# Access Compliance Report

## Public Rights-of-Way

Intersection ID: 42368	Main Street: FAIRVISTA_DR	Cross Street: HIGHLAND_CREEK_PY	Location: NE
ADA ID: 13E580FDD8E5	Ramp Type: PerpDiag	Initial Pass/Fail: Fail	Overall Compliance: No
		Severity Score: 37.5

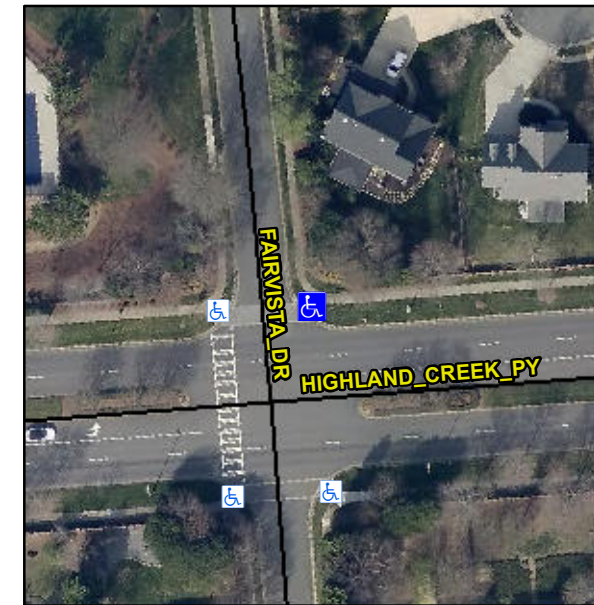
**Not Found, R304.2.2, R304.5.3**

Compliance	Description	Data	Compliance	Description	Data
N/A	Ramp Length (in)	73.0	No	Ramp Slope (%)	12.7
Yes	Ramp Width (in)	48.0	No	Ramp XSlope (%)	6.8
N/A	Flare Type LT	N/A	N/A	Flare Type RT	N/A
N/A	Flare Slope LT (%)	N/A	N/A	Flare Slope RT (%)	N/A
N/A	Flare Traversable LT?	N/A	N/A	Flare Traversable RT?	N/A
N/A	Landing Length (in)	N/A	N/A	DWS Provided?	N/A
N/A	Landing Width (in)	N/A	N/A	DWS Contrast?	N/A
N/A	Landing Slope (%)	N/A	N/A	DWS Length (in)	N/A
N/A	Landing X Slope (%)	N/A	N/A	DWS Full Width?	N/A
N/A	Landing Curb? (Y/N)	N/A	N/A	DWS Offset (in)	N/A
N/A	Shared Landing?	N/A			
N/A	Gutter Ponding?	N/A	N/A	Gutter Slope (%)	N/A
N/A	Gutter Lip Ht (in)	N/A	N/A	Gutter X Slope (%)	N/A
N/A	Painted X Walk1?	Yes	N/A	Painted X Walk2?	No
	X Walk 1 Direction	To W		X Walk 2 Direction	To S
N/A	X Walk 1 Width (in)	120.0	N/A	X Walk 2 Width (in)	N/A
	X Walk 1 Slope (%)	1.1		X Walk 2 Slope (%)	5.0
	X Walk 1 X Slope (%)	4.2		X Walk 2 X Slope (%)	0.7

**Remove & Replace Curb Ramp With Two New Directional Ramps or Equivalent.**
